SR 25 CO/West Bay Street From I-516 to the Bay Street Viaduct

NHS00-0002-00(923), P.I. No. 0002923
Chatham County, Georgia

Value Engineering Study Report

September 2009

Original Design
Graham Street

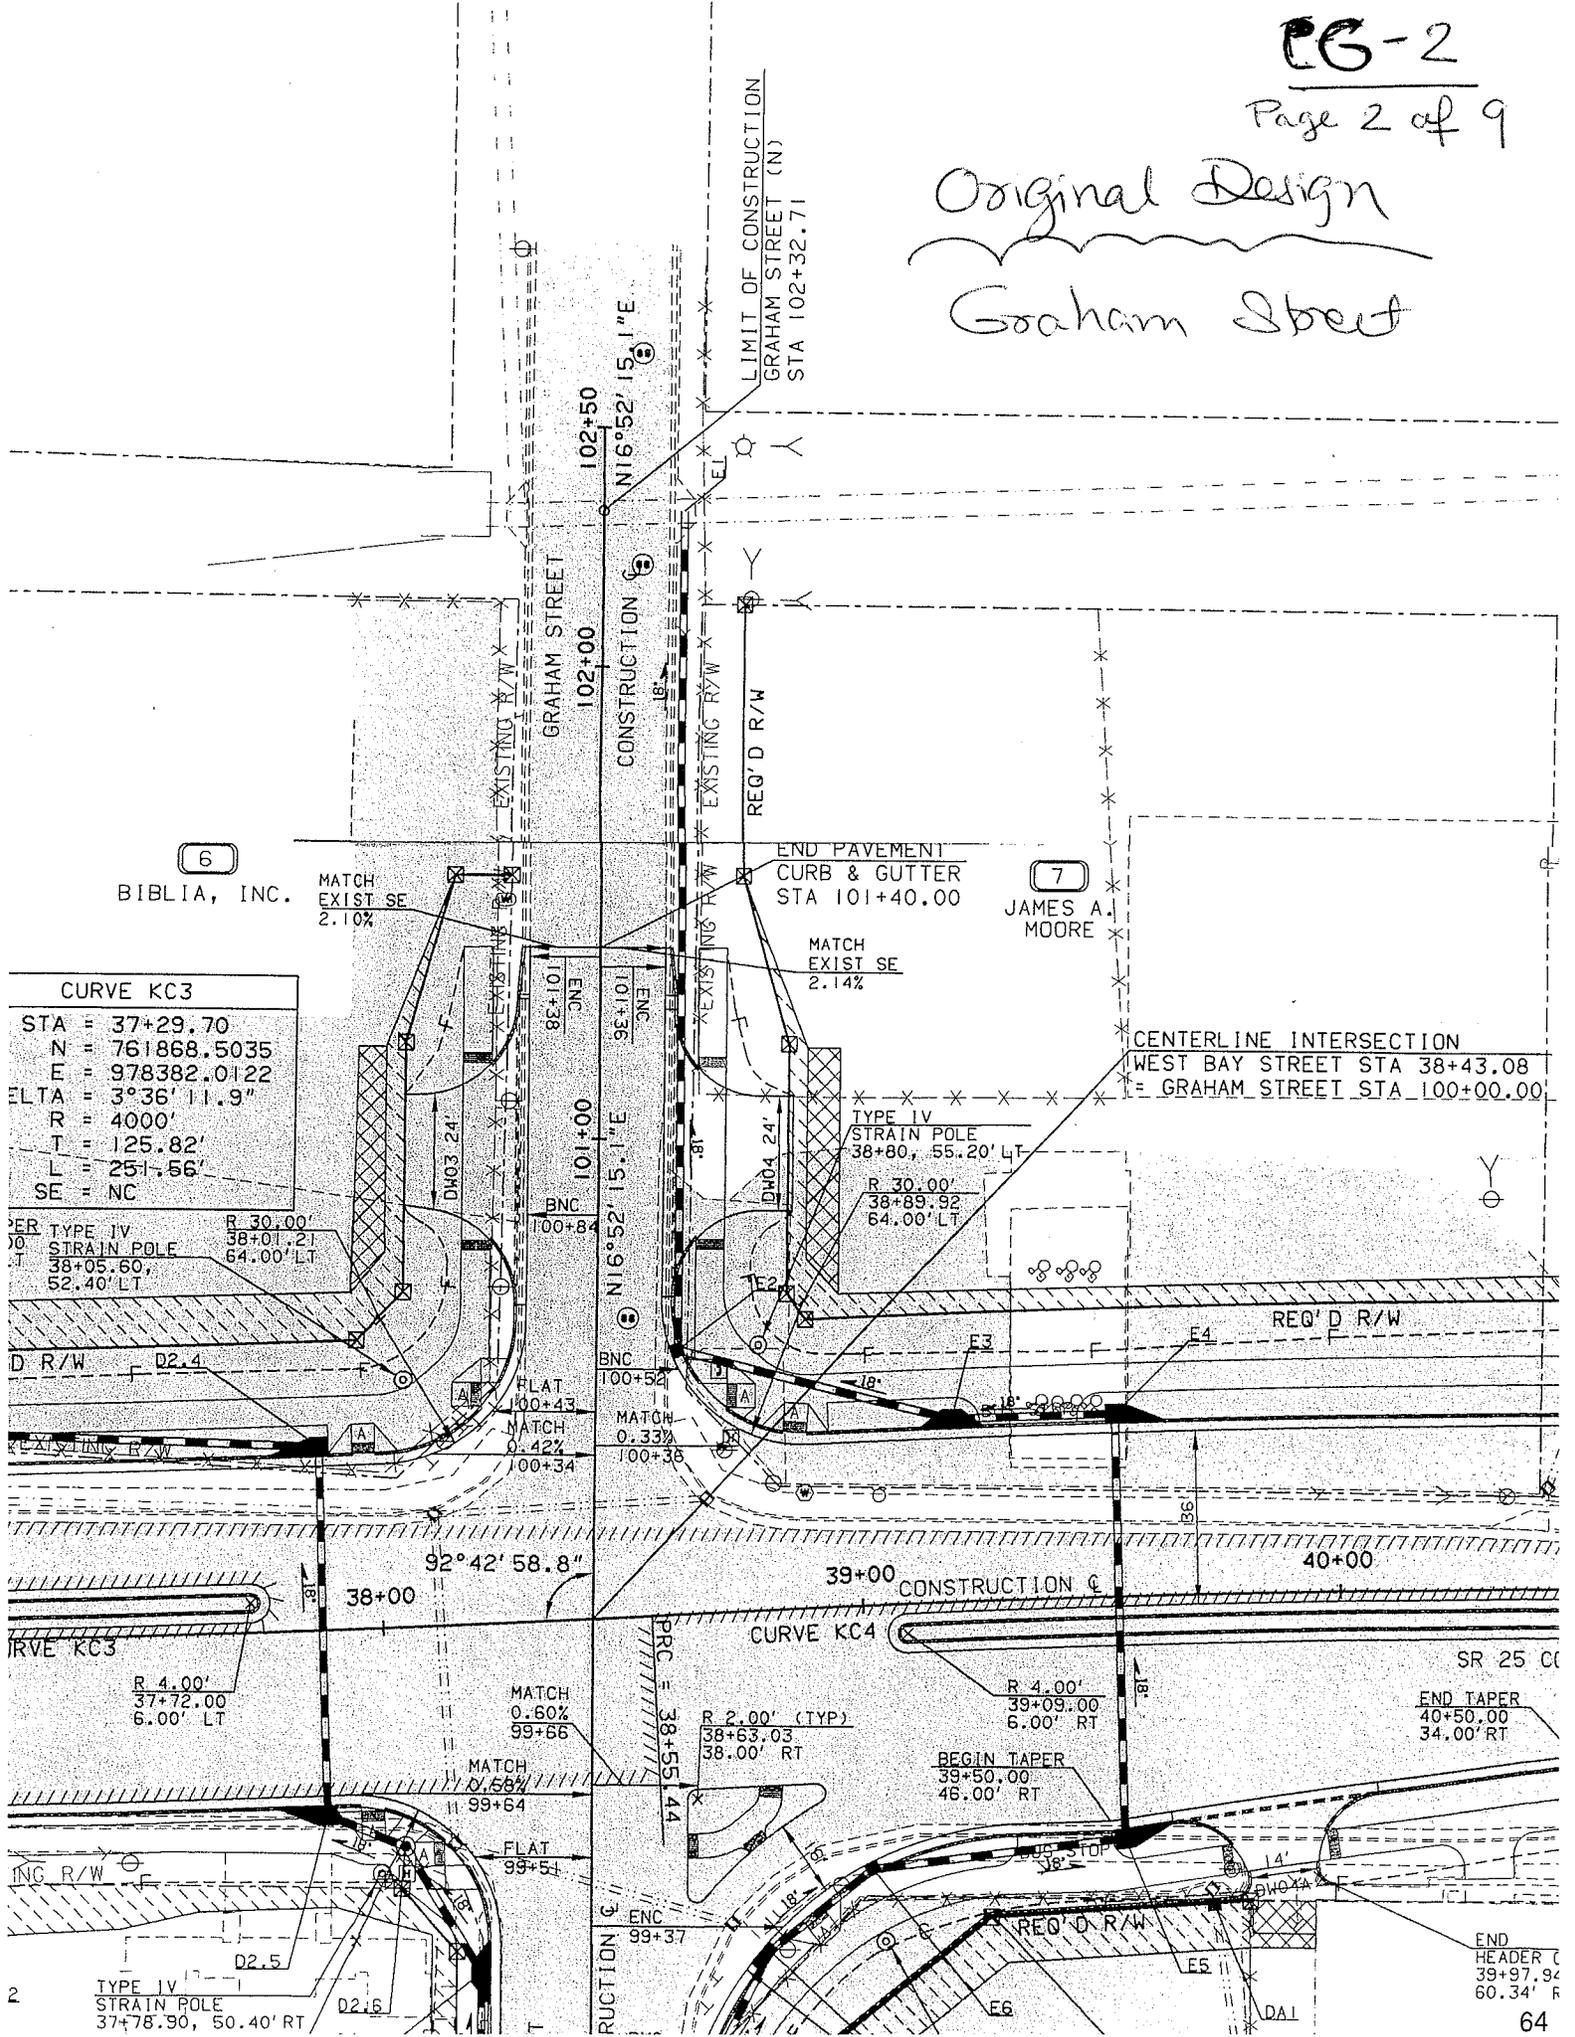
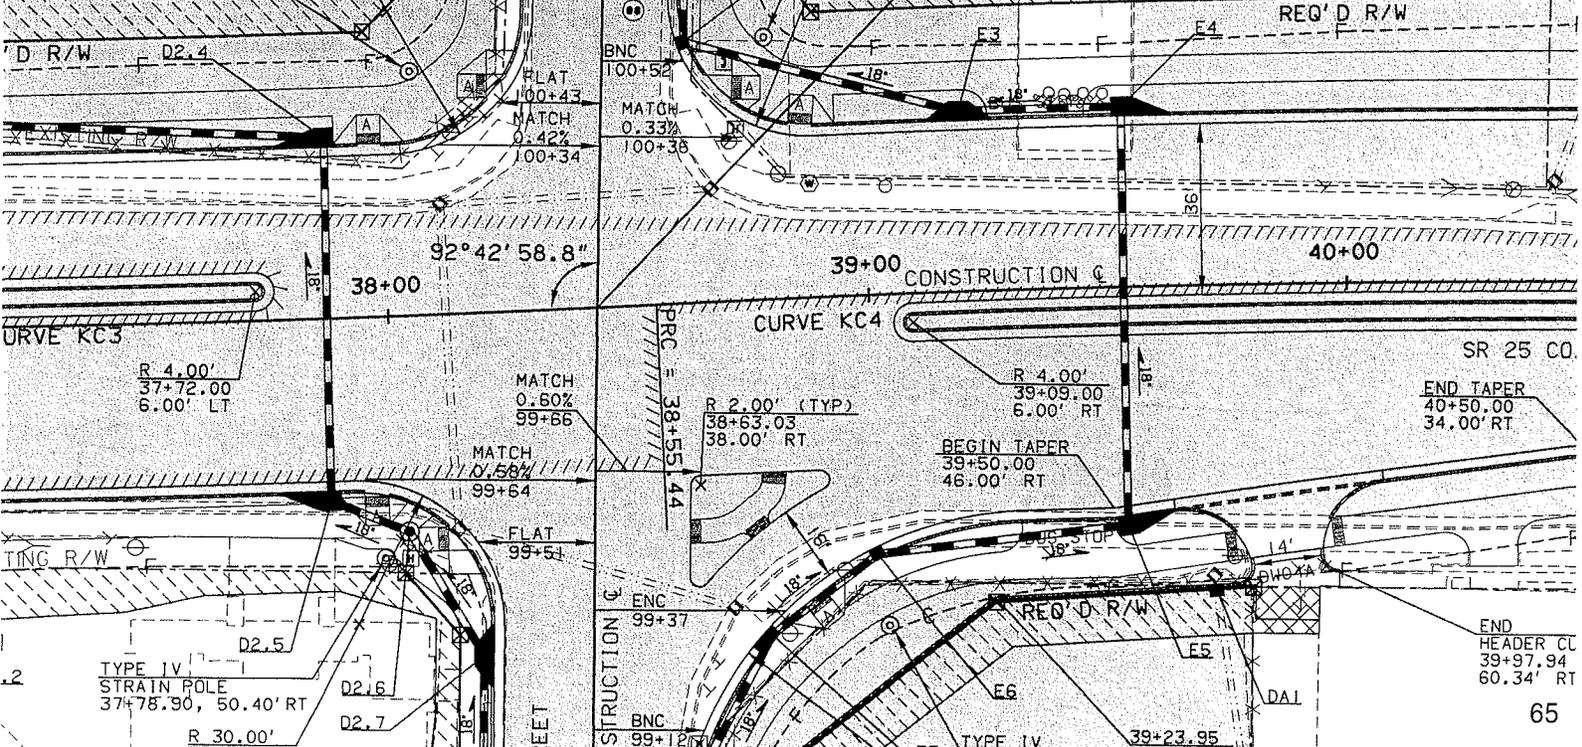
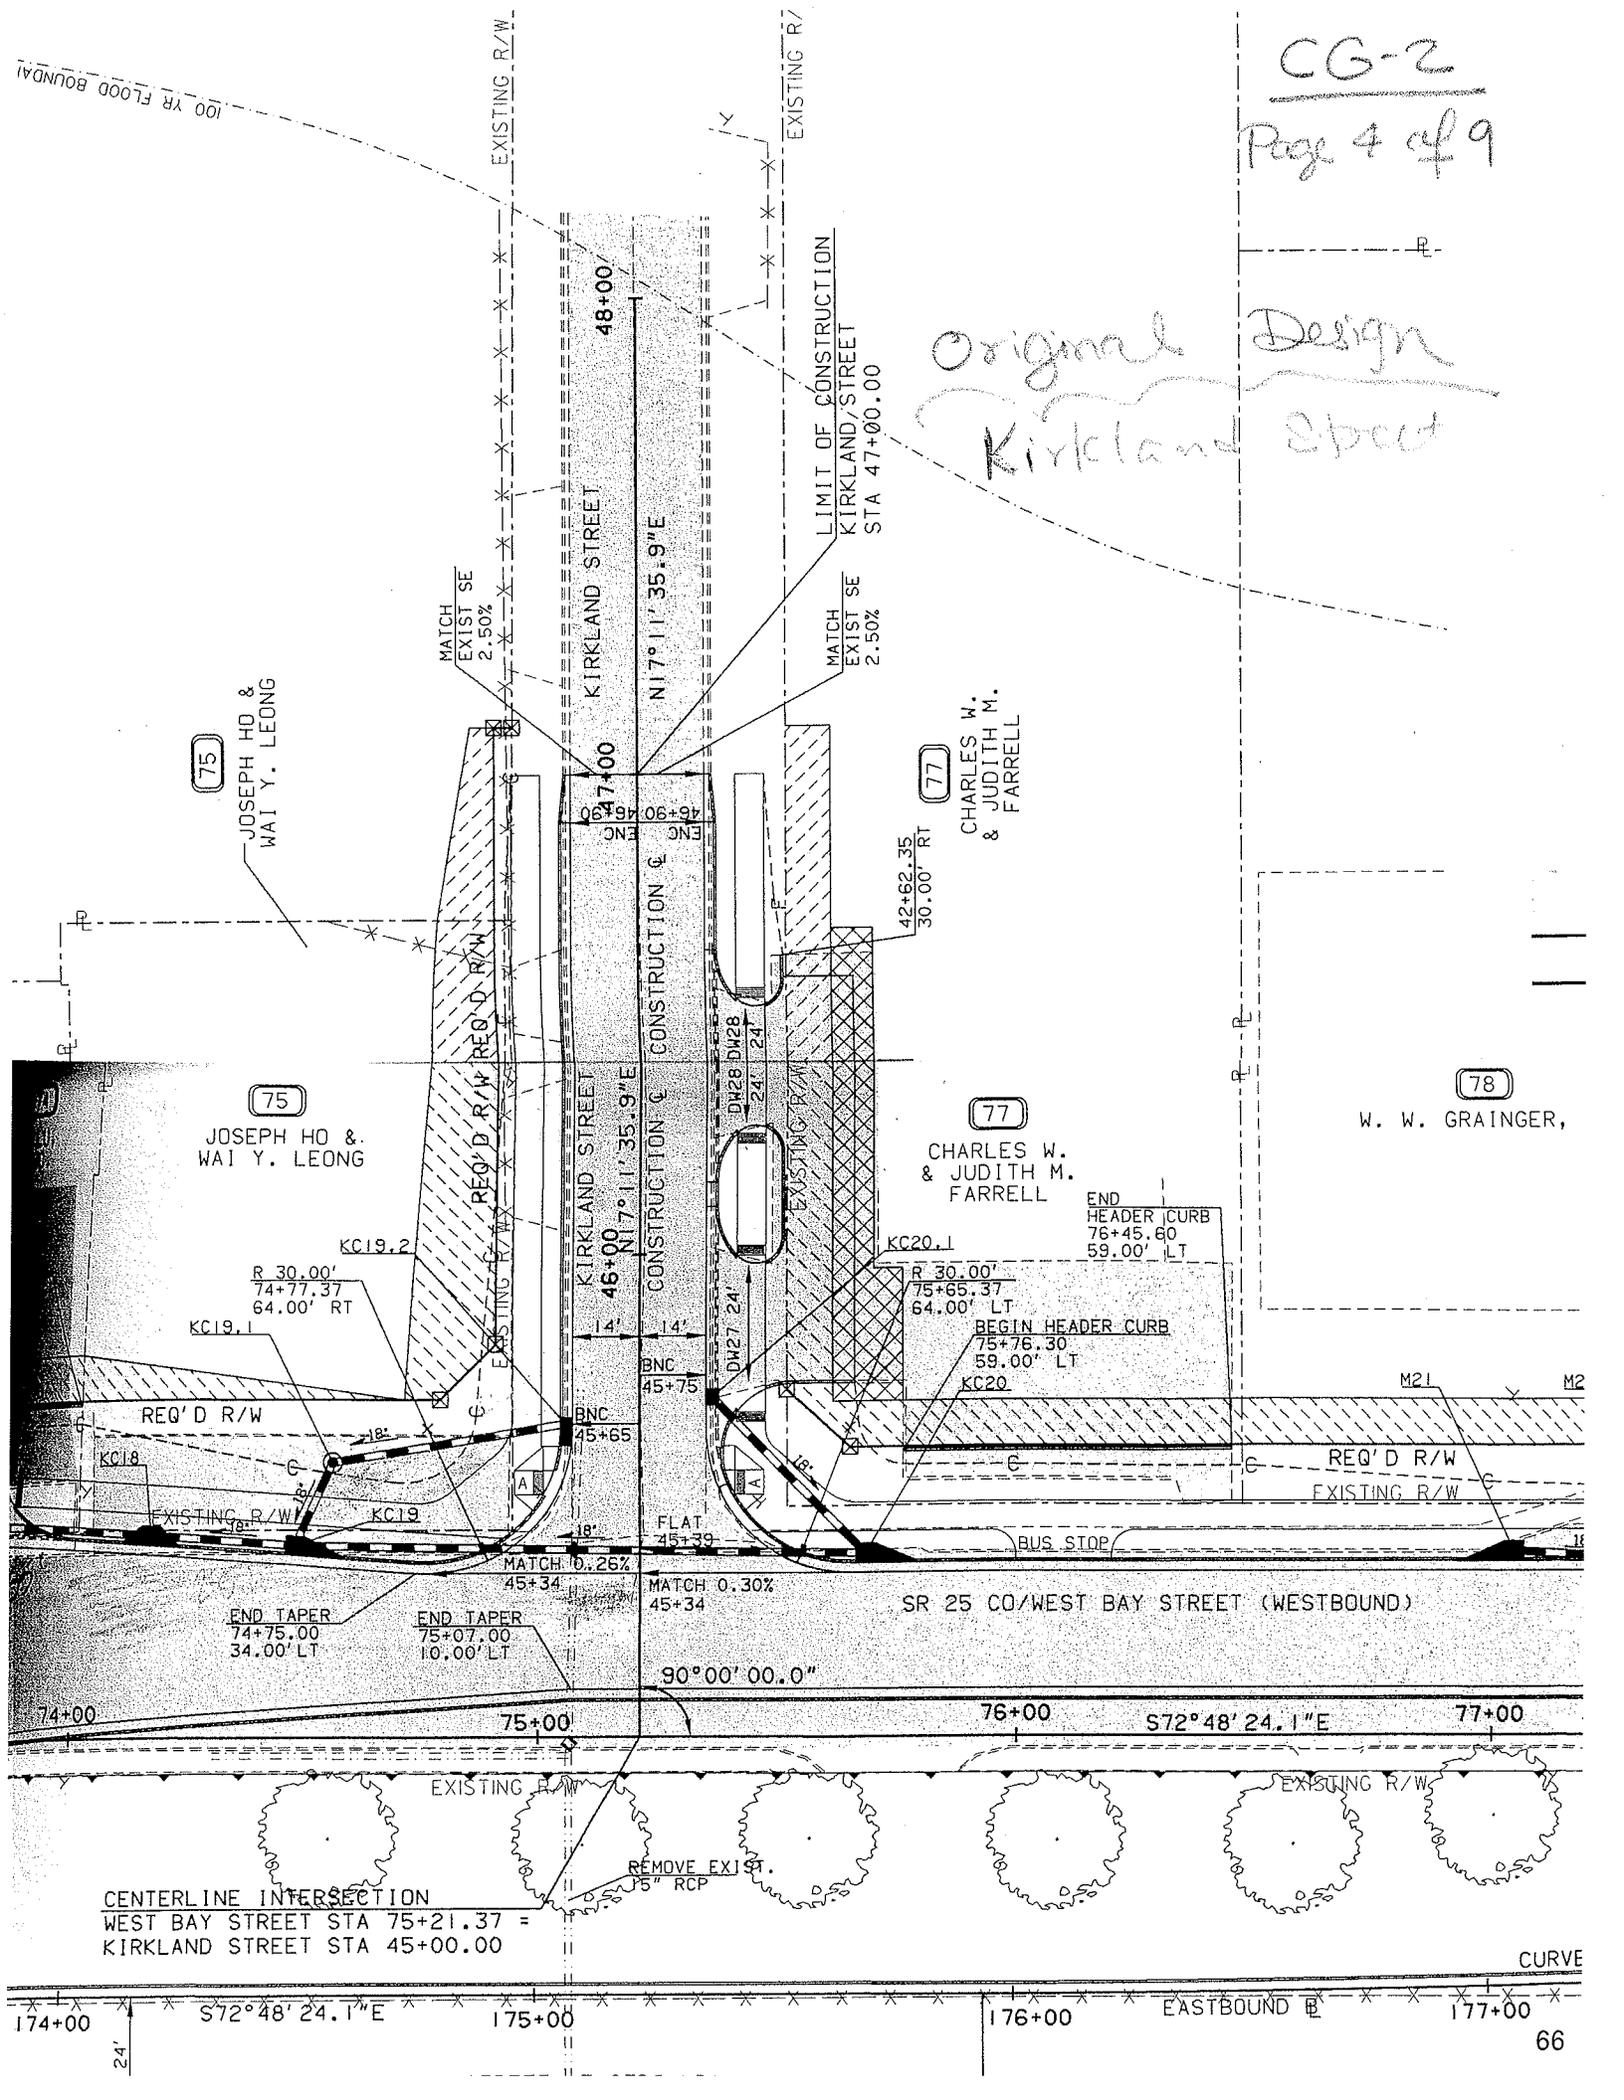
There is no appreciable advantage in removing existing curb and gutter and putting new ones along with 6-ft-wide sidewalks on the side roads. Considerable time and money can be saved by eliminating them.
